AMBIT ENGINEERING, INC. CIVIL ENGINEERS AND LAND SURVEYORS

RE: Request for TAC Site Plan Approval at 41 Salem Street, Tax Map 144 / Lot 31

The project received a Technical Advisory Committee recommendation of approval at the April 13, 2020 Technical Advisory Committee Meeting subject to stipulations. The stipulations, as well as our responses to the stipulations, are listed below:

PROPOSED RESIDENTIAL DEVELOPMENT 41 SALEM STREET PORTSMOUTH, NEW HAMPSHIRE PERMIT PLANS

EXISTING CONDITIONS PLAN **C1**

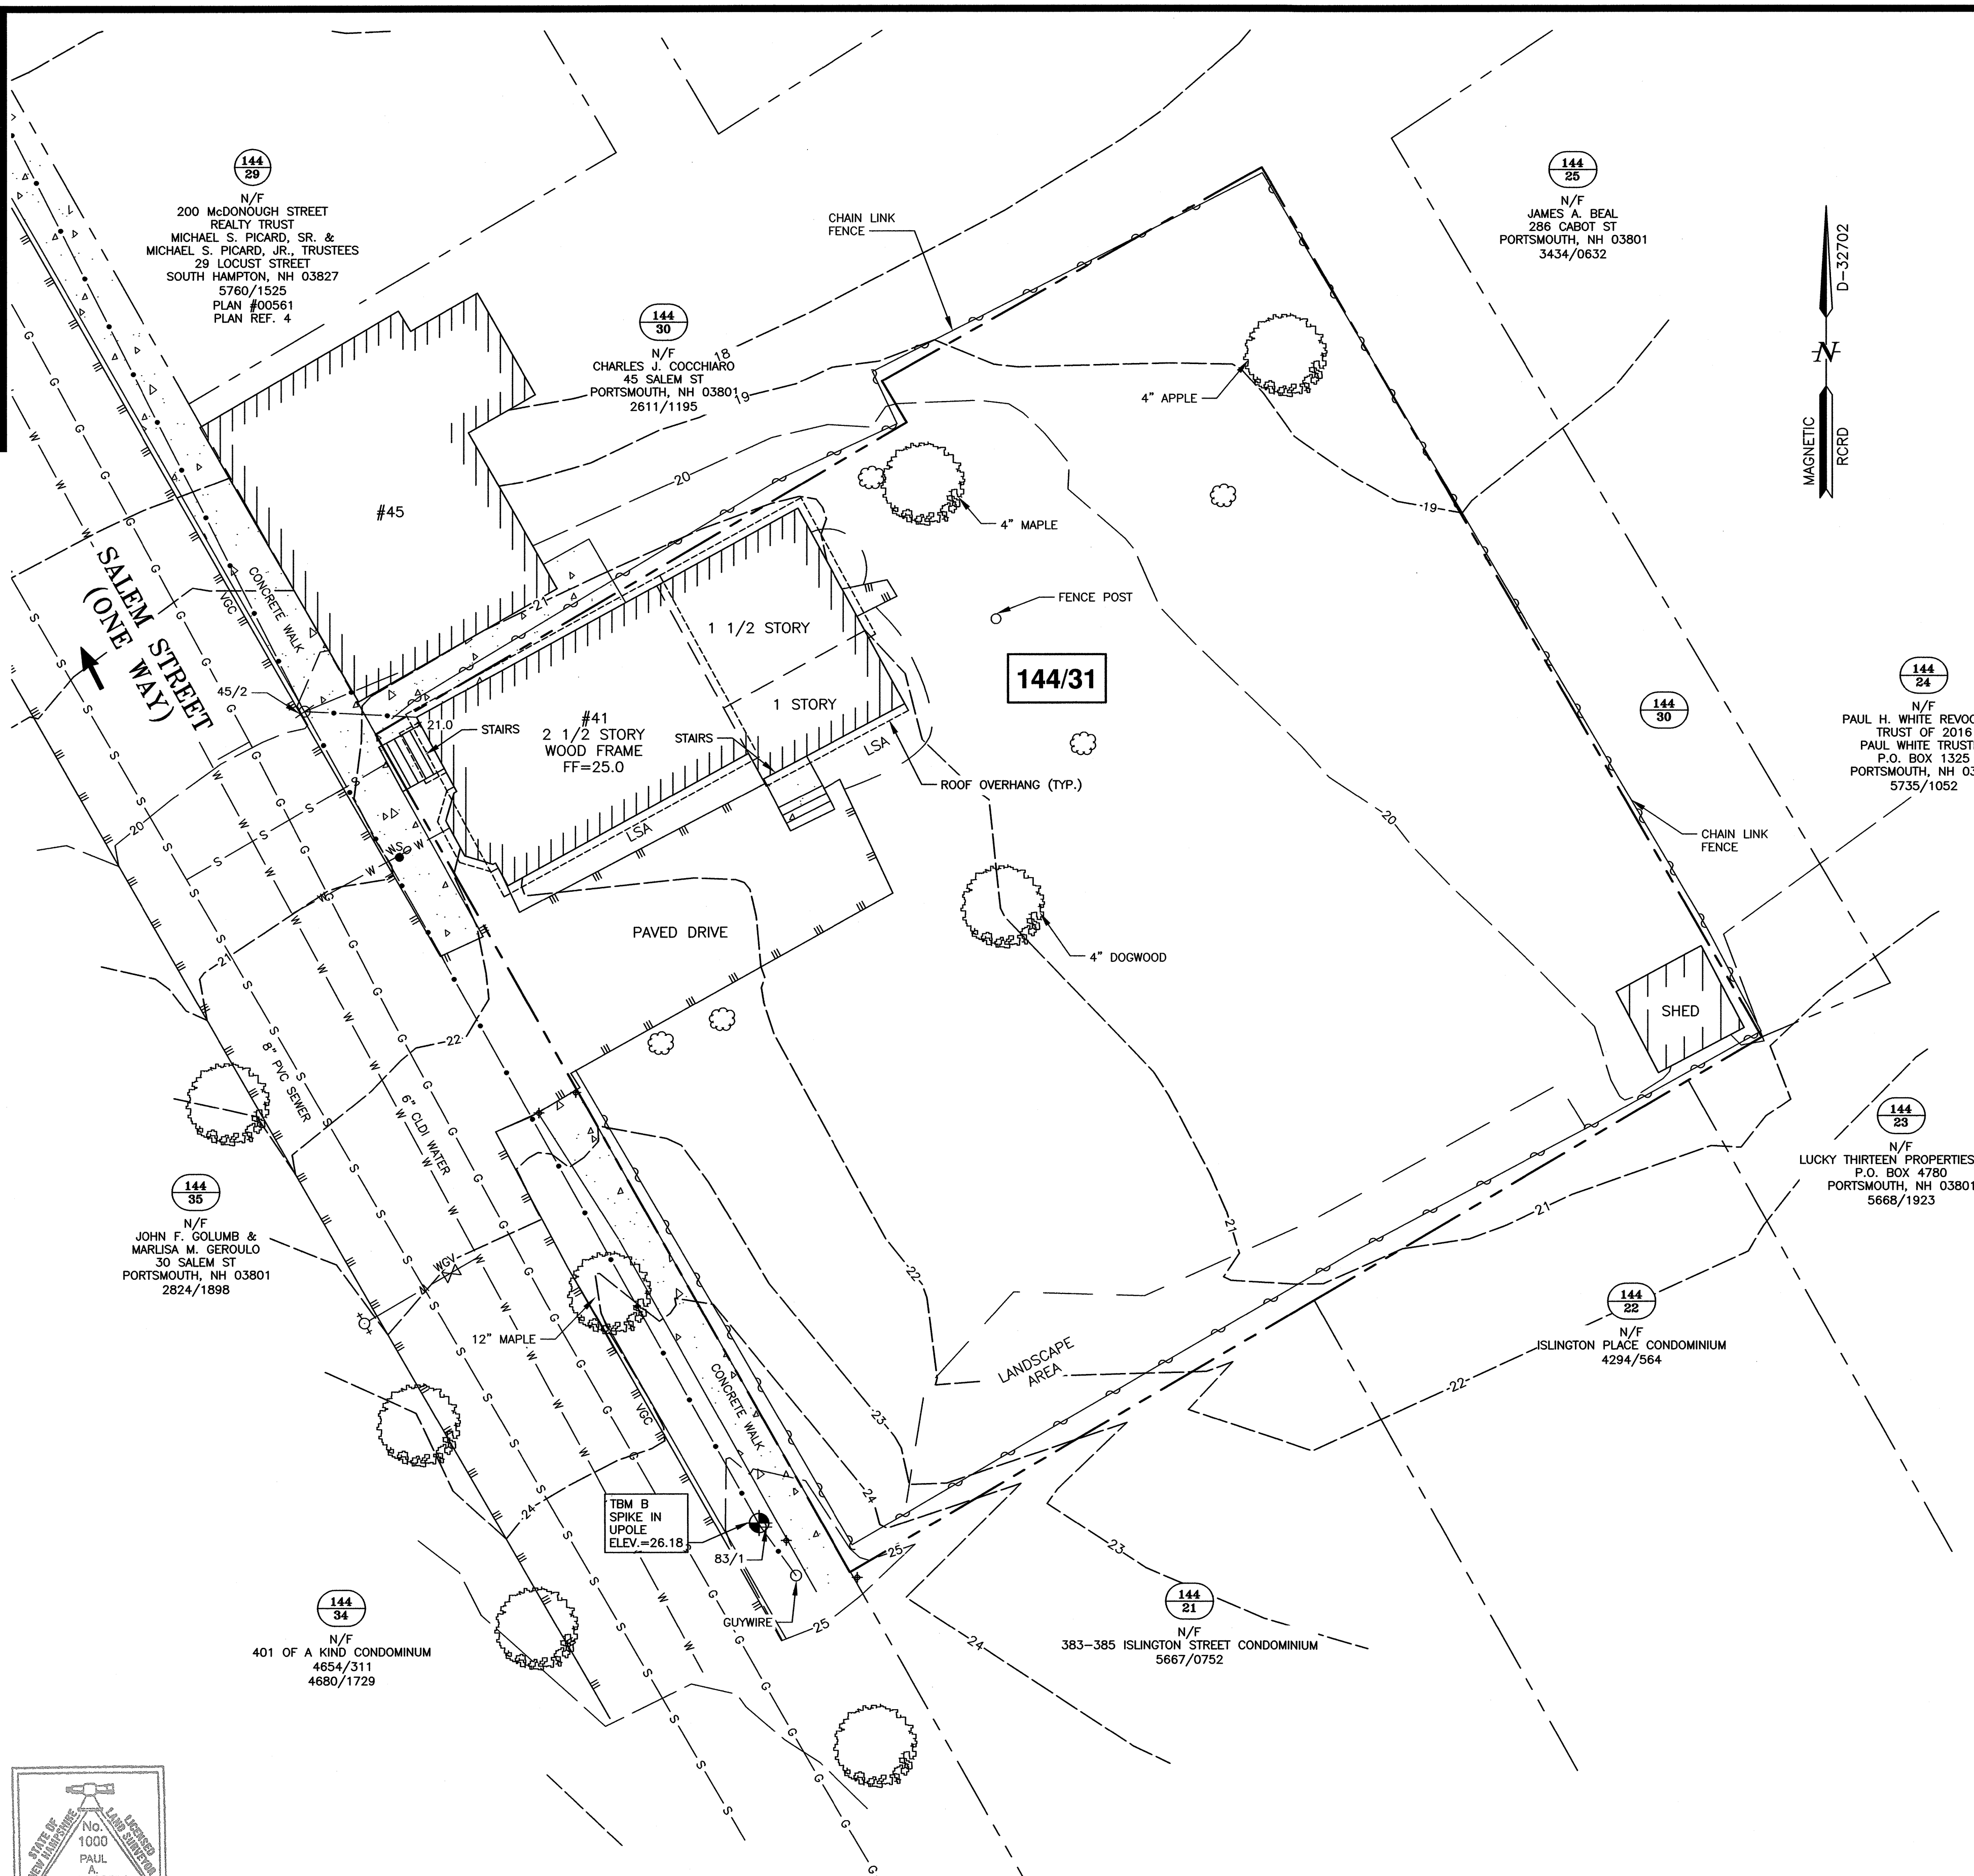
1. Plans shall be updated as follows:
 - a. Show existing sewer service on Existing Conditions plan and reuse as directed by DPW; **The sewer service is shown on Sheets C1 and C3.**

SITE LAYOUT PLAN

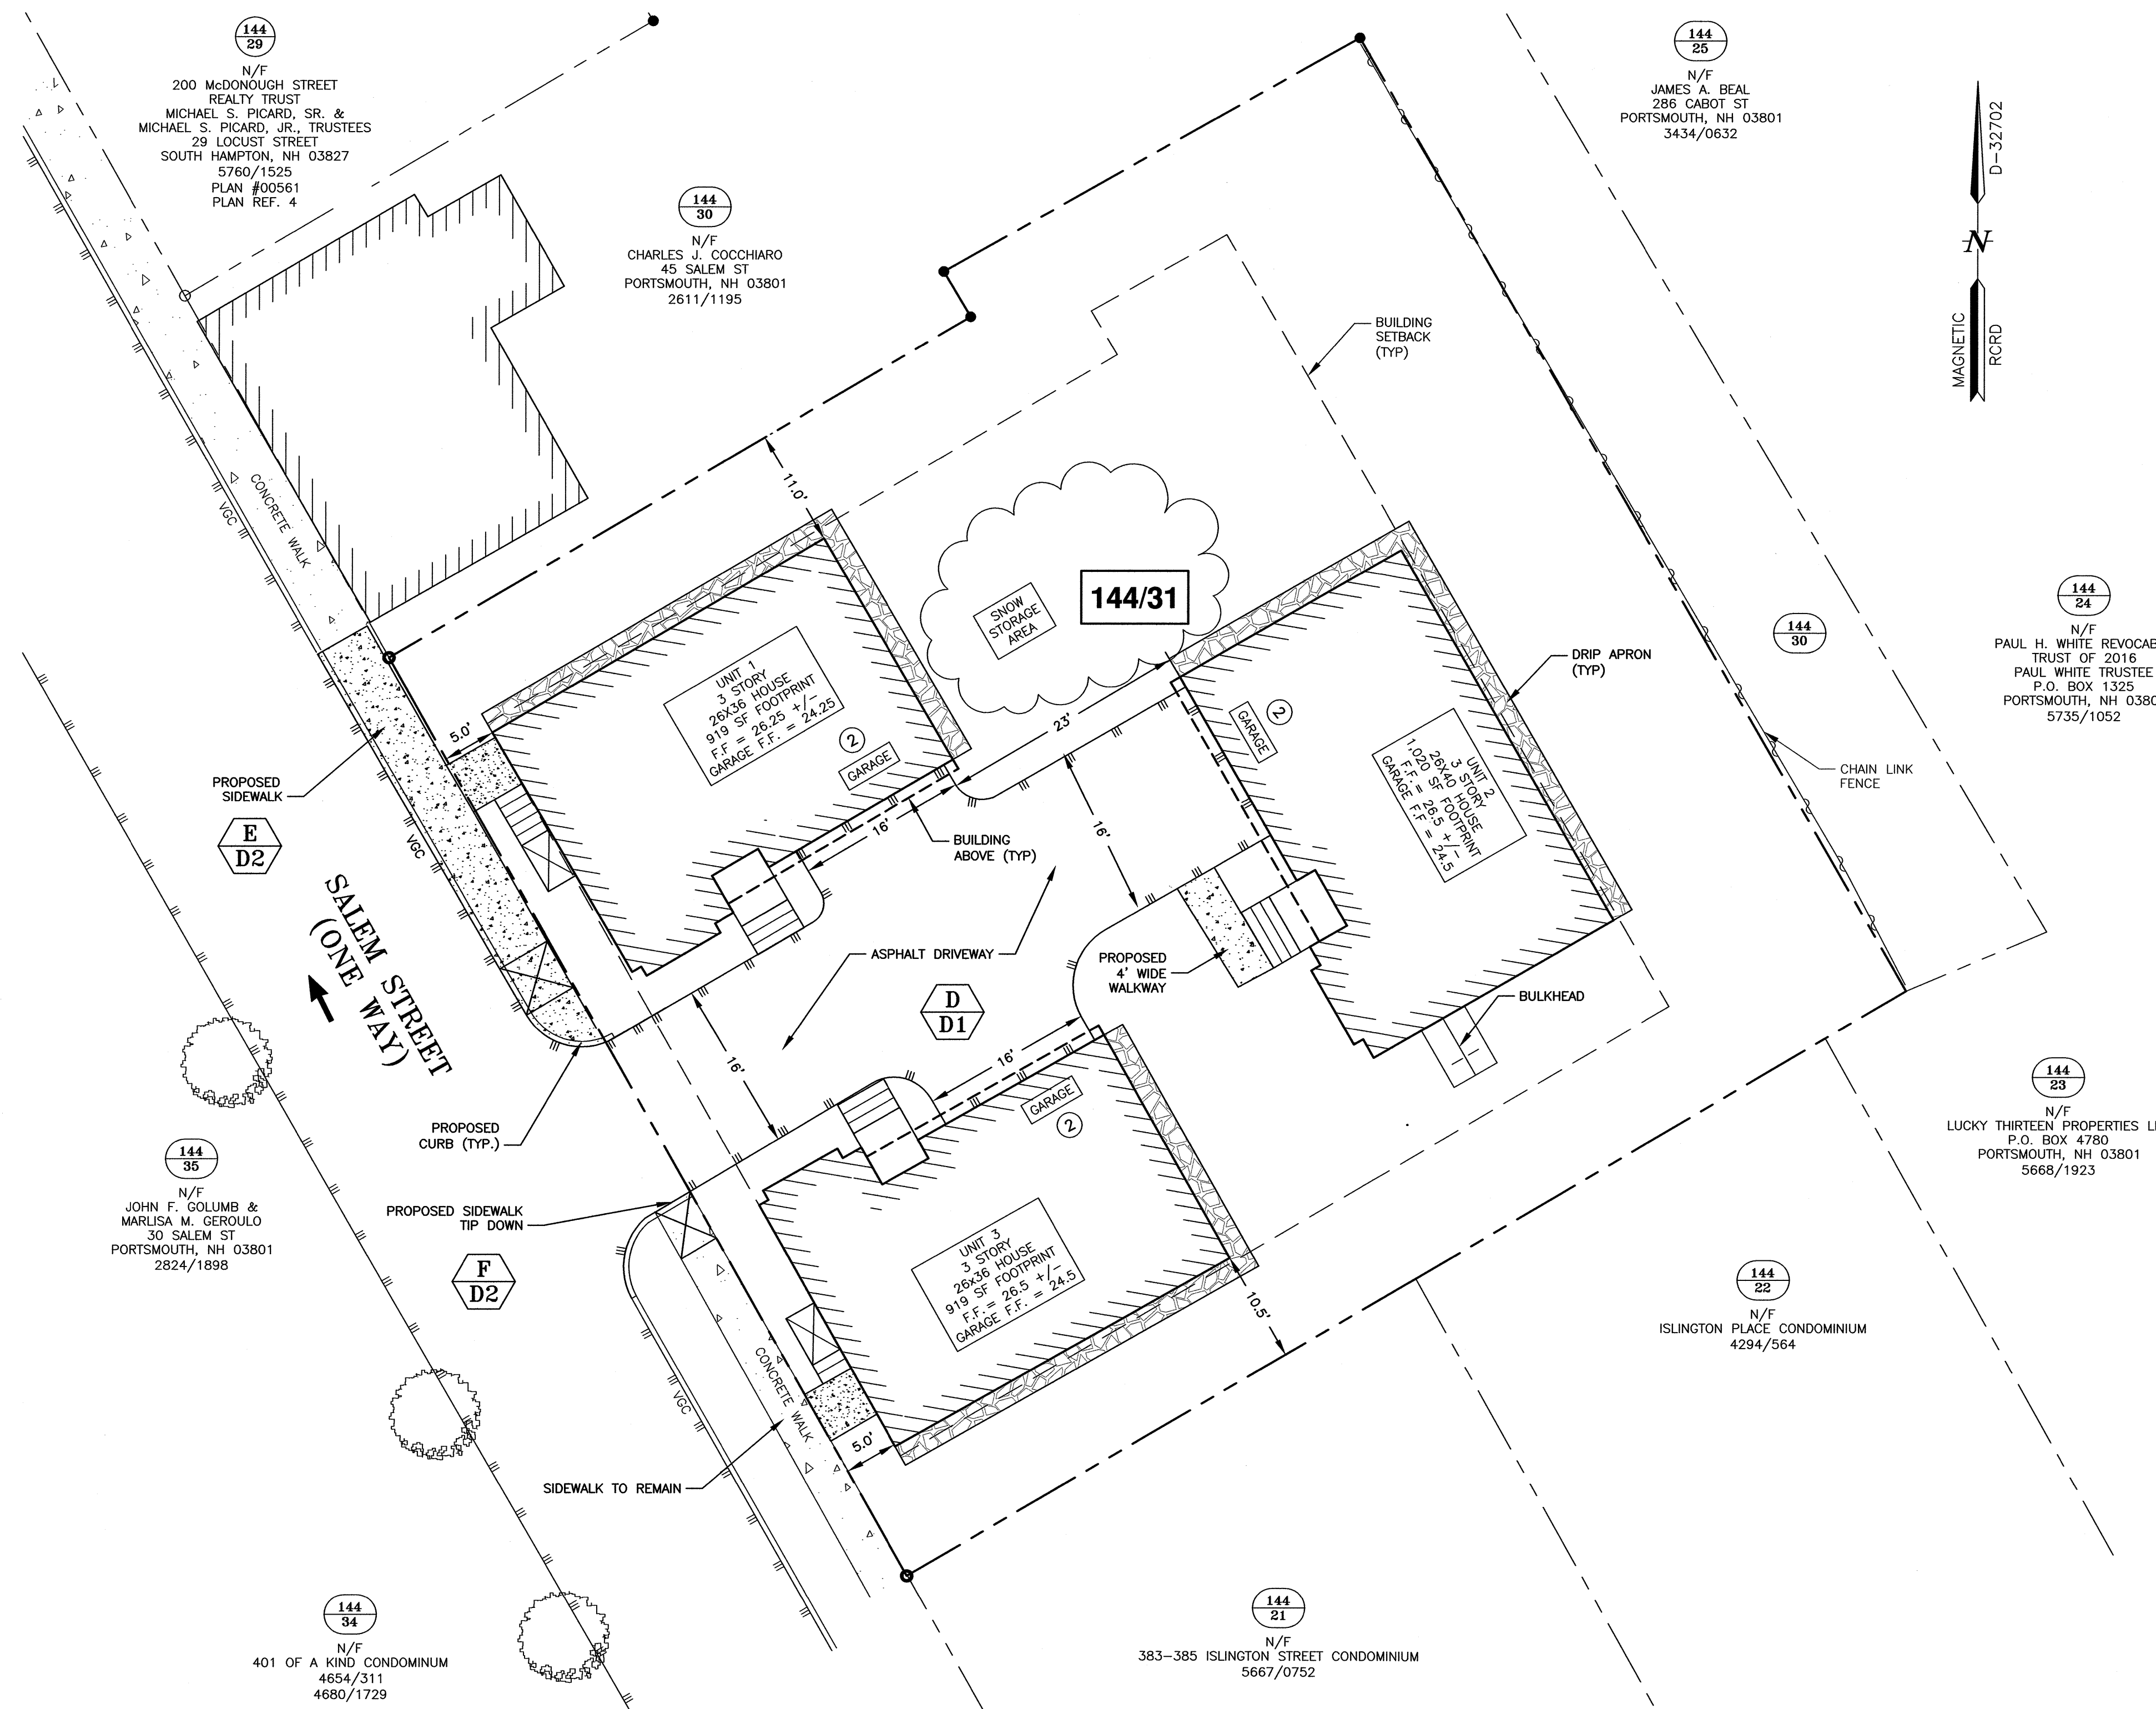
- f. Make sure drip edge is at least 12" wide than edge of eave; **Yes; eave is only 12 inches.**
 - g. Add note to plans that street to be milled and paved to repair the disturbed areas of Salem Street one year after utilities are completed; **This is shown on Sheet C2 as Note 11.**

- h. Add required note for existing water service to be capped at the main; **This is shown on Sheet C3 (if not re-used).**
 - i. Add note to plans that any damage to existing sidewalks to be repaired to DPW satisfaction; **This is shown on Sheet C2 as Note 12.**
